Access Compliance Report

Public Rights-of-Way

(Curb Ramps)

Intersection ID: 10031454	Main Street: MCDONALD_AV	Cross Street: N/A	Location: W
ADA ID: ED71880DF072	Ramp Type: Combination2	Initial Pass/Fail: Fail	Overall Compliance: No
			Severity Score: 43.75

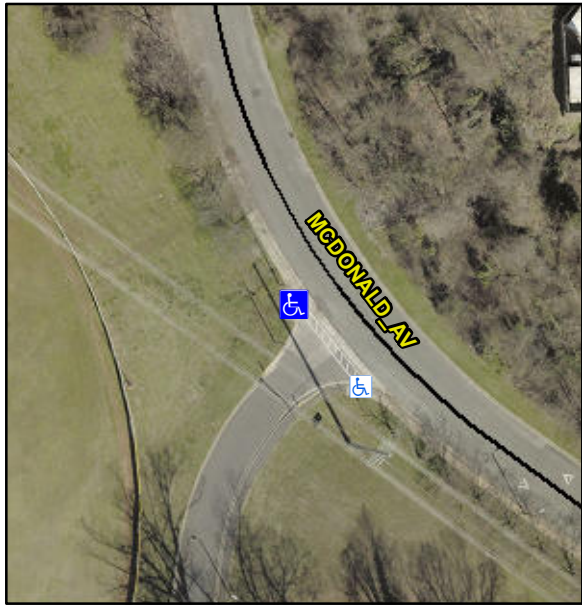
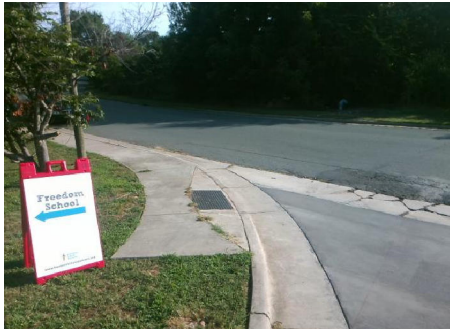
Codes/Mitigation Info/Possible Solution				Field Measurements/Component Compliance					
	Possible Solutions:			Compliance	Description	Data	Compliance	Description	Data
	Remove & Replace Entire Ramp.			N/A	Ramp Length LT (in)	64.0	N/A	Ramp Length RT (in)	N/A
				No	Ramp Width LT (in)	34.0	N/A	Ramp Width RT (in)	N/A
				No	Ramp Slope LT (%)	12.1	N/A	Ramp Slope RT (%)	N/A
				Yes	Ramp XSlope LT (%)	1.4	N/A	Ramp XSlope RT (%)	N/A
				N/A	Ramp Length (in)	26.0	No	Ramp Slope (%)	9.7
				Yes	Ramp Width (in)	59.0	No	Ramp XSlope (%)	3.5
	Surveyor Notes:			N/A	Flare Type LT	N/A	N/A	Flare Type RT	N/A
	N/A			N/A	Flare Slope LT (%)	N/A	N/A	Flare Slope RT (%)	N/A
				N/A	Flare Traversable LT?	N/A	N/A	Flare Traversable RT?	N/A
PROW/ADA:			N/A	Landing Length (in)	N/A	N/A	DWS Provided?	N/A	
Not Found, R304.5.1, R304.2.2, R304.5.3, R304.3.2			N/A	Landing Width (in)	N/A	N/A	DWS Contrast?	N/A	
			N/A	Landing Slope (%)	N/A	N/A	DWS Length (in)	N/A

N/A	Landing X Slope (%)	N/A	N/A	DWS Full Width?	N/A	
			N/A	Landing Curb? (Y/N)	N/A	N/A	DWS Offset (in)	N/A	
			N/A	Shared Landing?	N/A				
			N/A	Gutter Ponding?	N/A	N/A	Gutter Slope (%)	N/A	
			N/A	Gutter Lip Ht (in)	N/A	N/A	Gutter X Slope (%)	N/A	
			N/A	Painted X Walk1?	No	N/A	Painted X Walk2?	N/A	
				X Walk 1 Direction	To SE		X Walk 2 Direction	N/A	
				X Walk 1 Width (in)	N/A		X Walk 2 Width (in)	N/A	
				X Walk 1 Slope (%)	0.0		X Walk 2 Slope (%)	N/A	
				X Walk 1 X Slope (%)	9.3		X Walk 2 X Slope (%)	N/A	
			N/A	Ramp inside XWalk1?	N/A	N/A	Ramp inside XWalk2?	N/A	
				Road Slope (%)	N/A		Clear Space?	N/A	
				Road X Slope (%)	N/A	N/A	Clear Space to XWalk (in)	N/A	
						N/A	Any Obstruction?	N/A	
							Obstruction Type	N/A	
						N/A	Storm Grate/Utility Hazard?	N/A	
							Storm Grate/Utility Type	N/A	
						Yes	Surface Condition? (G/P)	Good	
							Curb Slope (%)	6.2	
Street 1 Name			StopSign
